Act permit application (#L-20386-4P-P-N)

Re: Additional Public Comment on SHM Rockland, LLC's Natural Resources Protection

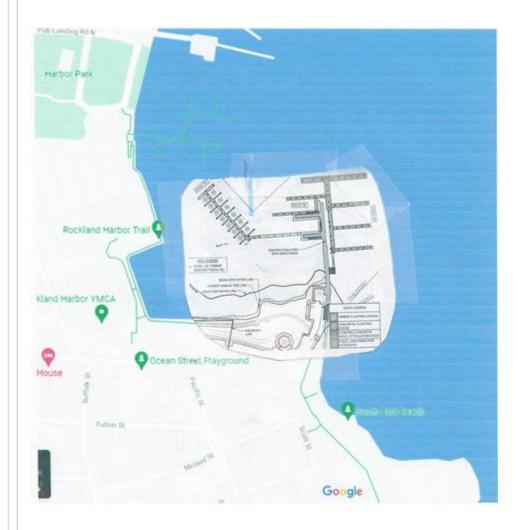
1. I want to make sure that the proposal is considered carefully in terms of its close proximity to Sandy Beach (sometimes called South End Beach, as on this image below showing the expansion plan proposal in context with the surrounding parks). As I said in my previous email, I have been the volunteer gardener at Sandy Beach for over ten years and I see how much it is enjoyed by the community year-round.

I don't know how disruptive the marina expansion could be for the people at Sandy Beach, but I am concerned about more boats, especially the 200'-240' boats, coming in and out near people trying to relax, unwind, enjoy themselves. Plus if the boats can be seen and heard in their slips from Sandy Beach and Sandy Beach Park it could take away from the open feeling people currently enjoy there. Those four 150' docks they want to put in near Sandy Beach can hold boats that are at least 200' long, so they need to be viewed as how that extra 50' or more poking out from the docks will be viewable from Sandy Beach.
